# SERVICE No. 991A BULLETIN

DATE: January 29, 1996

(Service Bulletin No. 991A supercedes and voids Service Bulletin No. 991 dated January 10, 1996)

**Replacement or Modification of the  
Alternator Out Light Fuse**

**PA-28-161 (CADET)**  
 (Refer to the Maintenance Manual as necessary.)

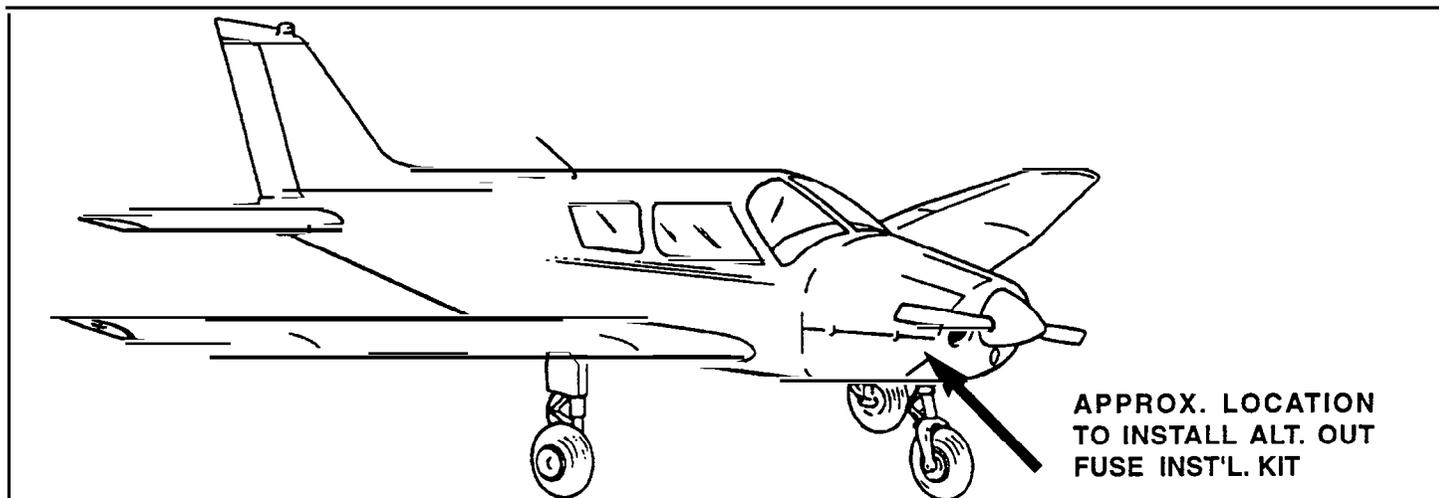
1. Remove the engine cowling.
2. Locate the alternator AUX terminal.
3. Remove the existing wire from the alternator AUX terminal and install the Alt Out Fuse Installation Kit Piper Part Number 766-293 per kit instruction.
4. Secure the fuse holder with a Ty-rap.
5. Perform run up and functional check.
6. Reinstall the engine cowling.

**PA-28R-201 (ARROW)  
PA-28R-201T (TURBO ARROW)**

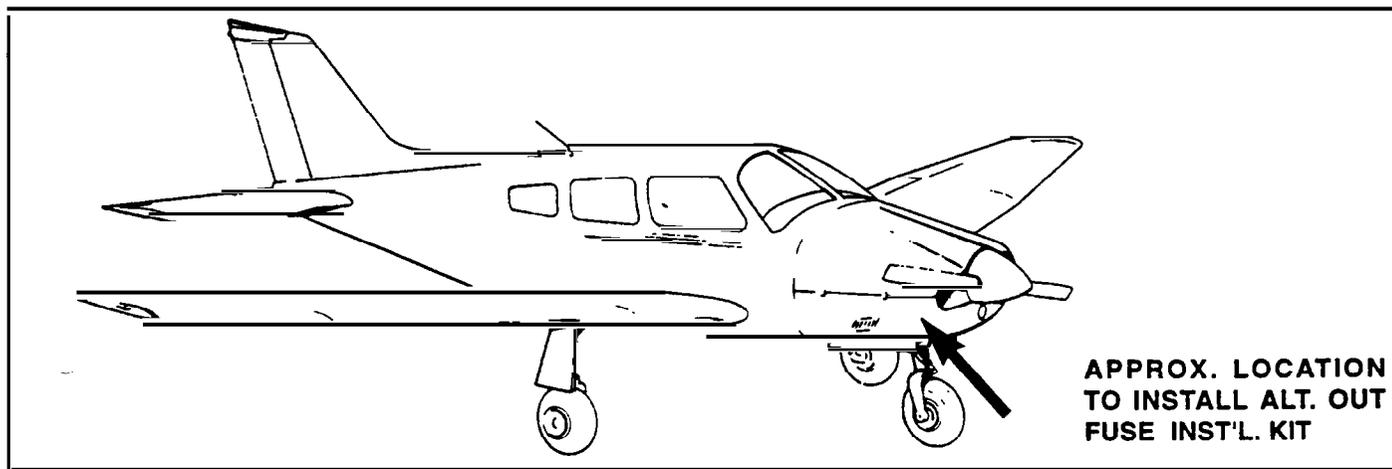
1. Remove the engine cowling. (Arrow shown as typical.)
2. Locate the alternator AUX terminal.
3. Remove the existing wire from the alternator AUX terminal and install the Alt Out Fuse Installation Kit Piper Part Number 766-293 per kit instruction.
4. Secure the fuse holder with a Ty-rap.
5. Perform run up and functional check.
6. Reinstall the engine cowling.

**PA-38-112 (TOMAHAWK)**

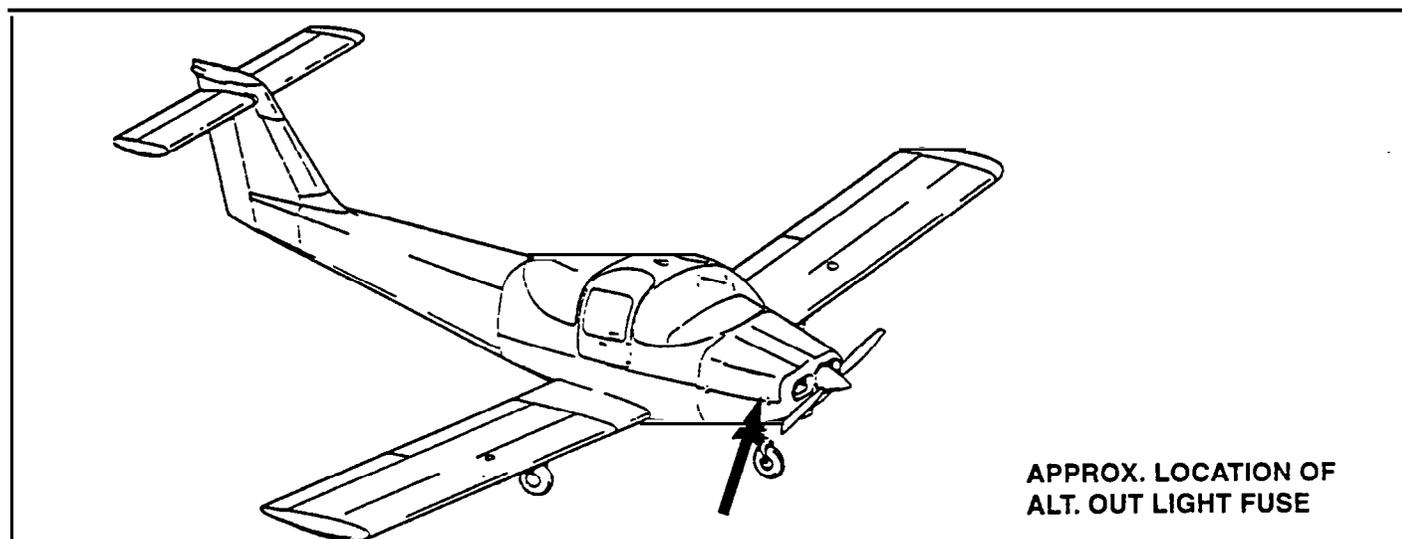
1. Remove the engine cowling to gain access to the alternator.
2. Locate the alternator AUX terminal and follow the wiring to the fuse holder between wire (WIC20) and (WID20).
3. Remove the existing fuse and install new fuse part number 461-643. *NOTE: Inspect condition of the existing fuse holder and replace as required.*
4. Perform run-up and functional check.
5. Reinstall the cowlings.

**PA-31, 31-325 (NAVAJO, NAVAJO C/R)  
PA-31-350 (CHIEFTAIN & T1020)  
PA-31P (PRESSURIZED NAVAJO)**

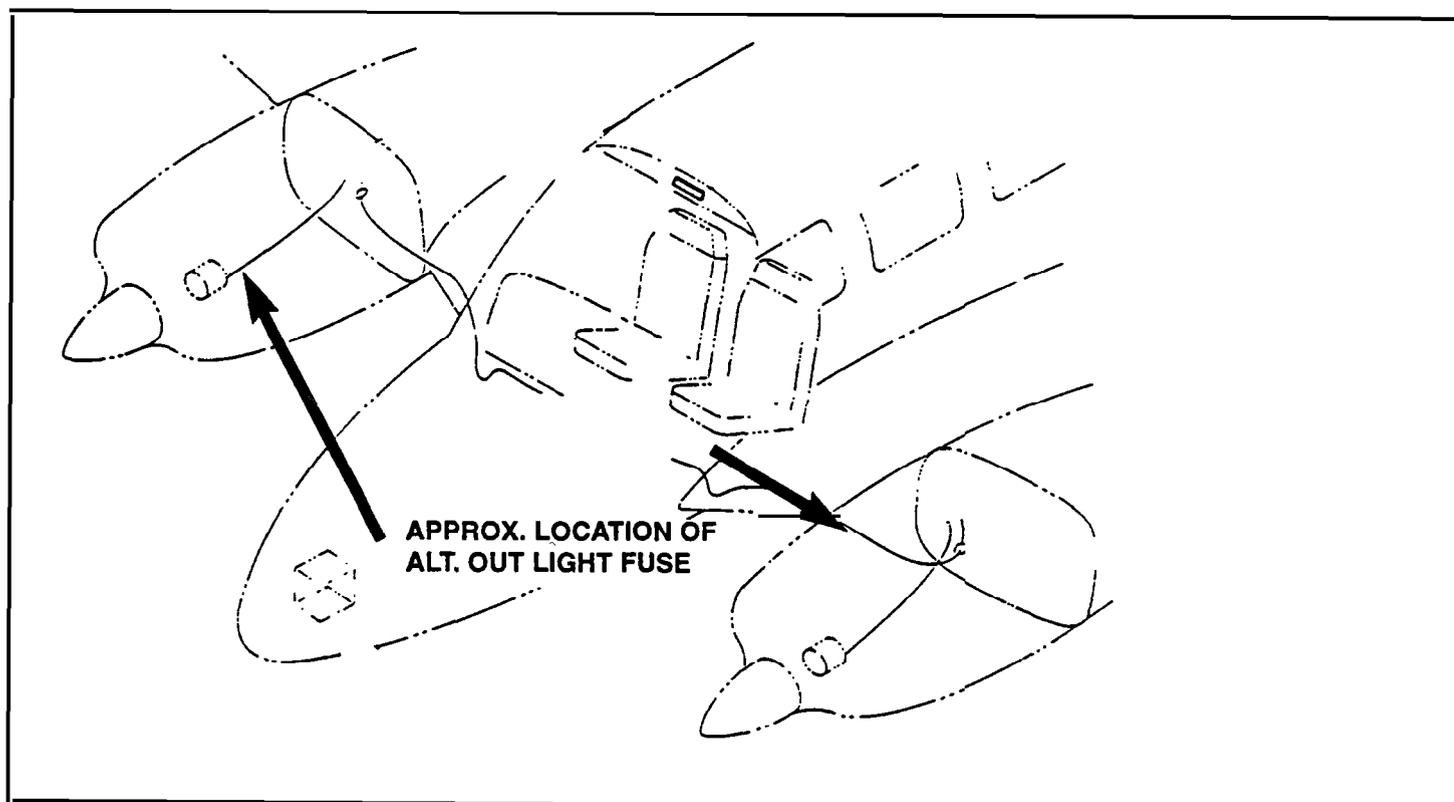
1. Remove the upper and lower engine cowlings to gain access to the alternators.
2. Locate the alternator AUX wire on the left and the right alternator.
3. Follow the wire to the fuse holder.
4. Remove the existing fuse and install fuse part number 461-643, secure wires and fuse holders after installation. *NOTE: Inspect condition of the existing fuse holder and replace as required.*
5. Perform run-up and functional check.
6. Reinstall the cowlings.
